Land at North West Bicester

Technical Note 2: Response to LLFA Drainage Comments

18th March 2022

Indicative SuDS Layout

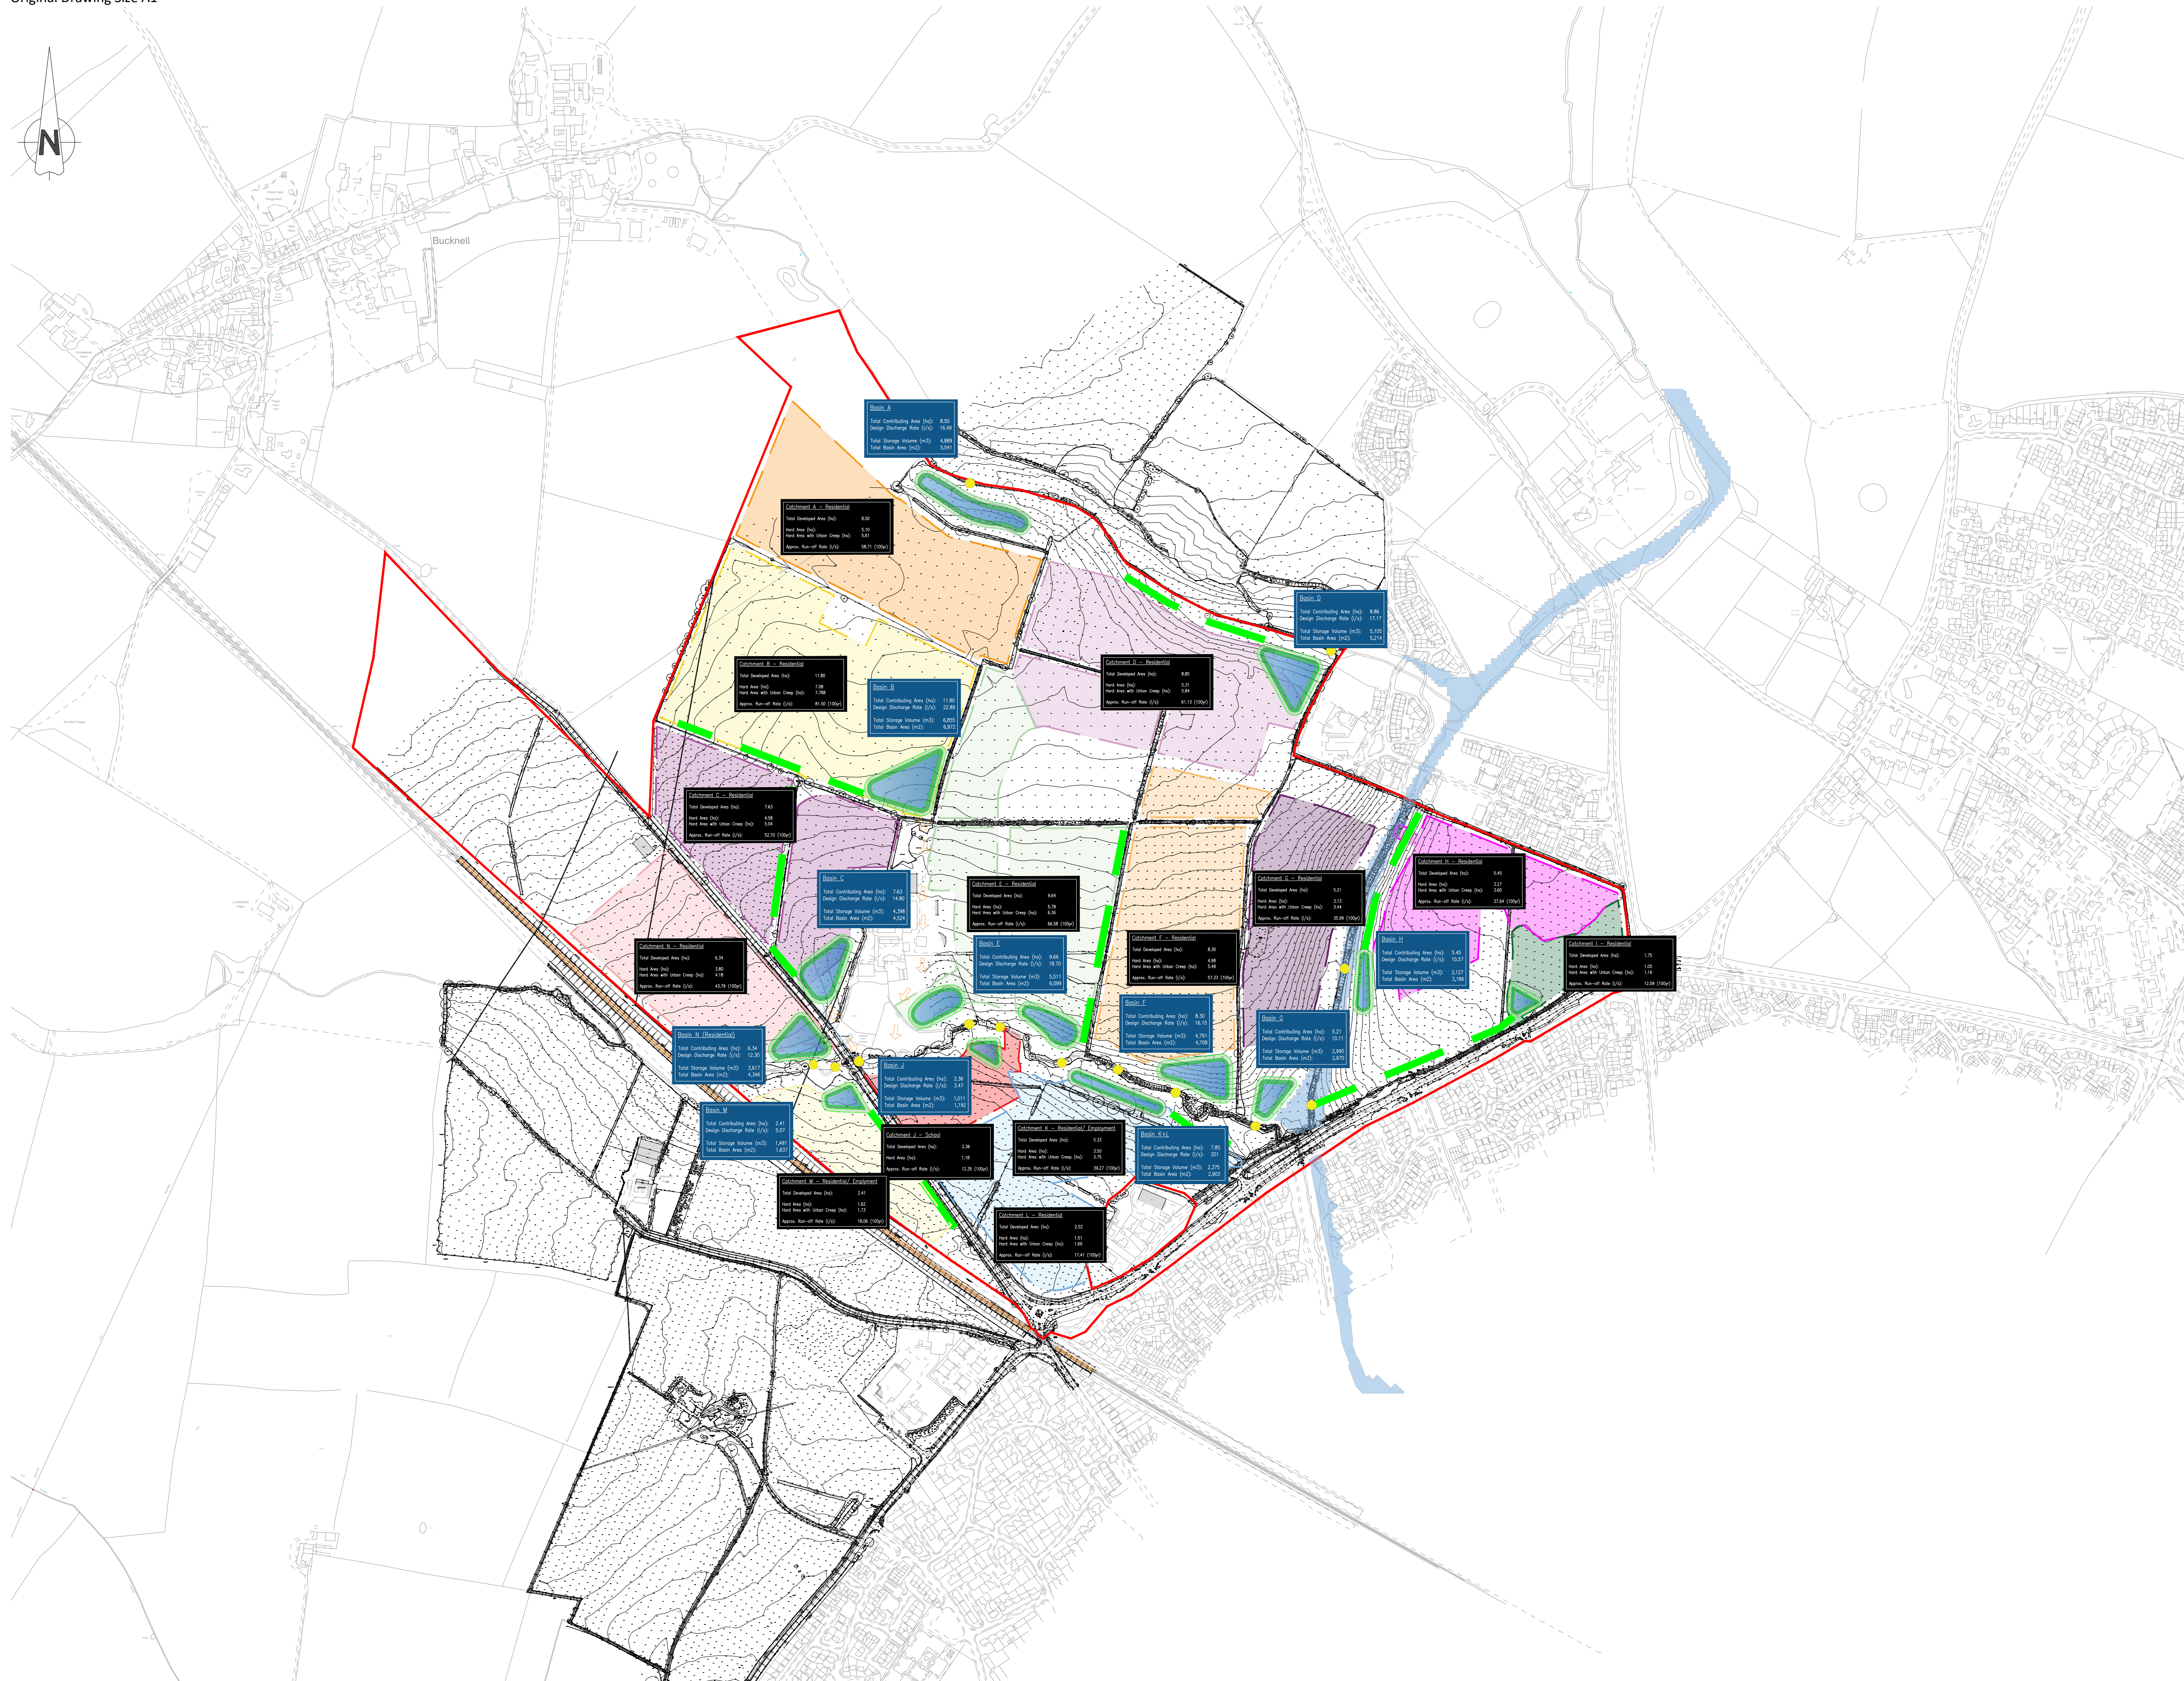
- 2.3 *The FRA explains the surface water drainage strategy however a surface water drainage drawing is required to demonstrate the surface water strategy. Proposed SuDS features and drainage infrastructure needs to be shown indicatively. Outfall locations to be shown, storage details of proposed SuDS features and infiltration rates if applicable.*

- 2.7 The yellow circle on the plan indicative a suggested outfall location for each of the basins.
- 2.8 *The catchment areas have been broken down in the FRA, however a Catchment plan is required to highlight the extent of the areas. Stating the total impermeable area and the impermeable area including urban creep.*

2.11 *Surface water exceedance flow plans required to demonstrate how the site is draining to ensure all surface water is being picked up by the proposed drainage infrastructure.*

- 2.4 A drainage strategy plan (10663-DR-01 D) has been provided as Appendix A of the Flood Risk Assessment (FRA). Drainage Strategy 10663-DR-01 E, have been appended to this note. This strategy plan includes clearer catchments areas and exceedance routes. The split between impermeable catchment area and impermeable area with urban creep has also been provided on the new plan.

- 2.6 On the drainage plan, the fourteen catchments have been coloured coded and each basin has its own blue information box. Within this box provides the area of the catchment, designed discharge rate, area of basin, m², and the volume required, m³.

- 2.9 Illustrated on drainage strategy plan (10663-DR-01 E), are the fourteen colour coded catchment areas across

2.10 The black information boxes on the DR plan states:

- the catchment area,
- impermeable area,
- impermeable area with urban creep,
- the existing 100-year runoff rate.

2.12 Plan 10663-DR-01 E, illustrates a series of swales adjacent to the edge of the catchment parcels which will convey surface water from that parcel into the associated catchment detention basin.

2.13 Exceedance flow routes are also illustrated for the basins that are not directly adjacent to one of the onsite watercourses.
